PRODUCT INFORMATION NOTIFICATION

PIN: PIN152801   **Date:**   July 07, 2015

Subject: Revision in Silicon Die for USB 3.0 Hub Controllers (HX3 Family) Products

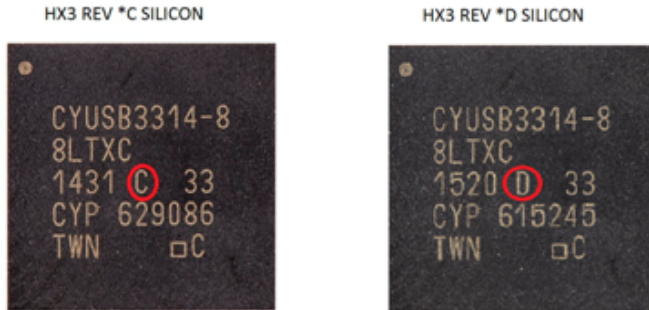
Cypress is revising the HX3 die to Rev. *D from Rev. *C silicon to improve the yield. Cypress will continue to ship the current Rev. *C silicon version for the next several months, after which HX3 shipments will seamlessly migrate to the Rev. *D silicon. There are no changes to the ordering part numbers or datasheet parameters.

Method of Identification:
Please refer to the picture below for the distinction between the Rev. *C silicon and the Rev. *D silicon indication on the package marking (third row, circled in red).
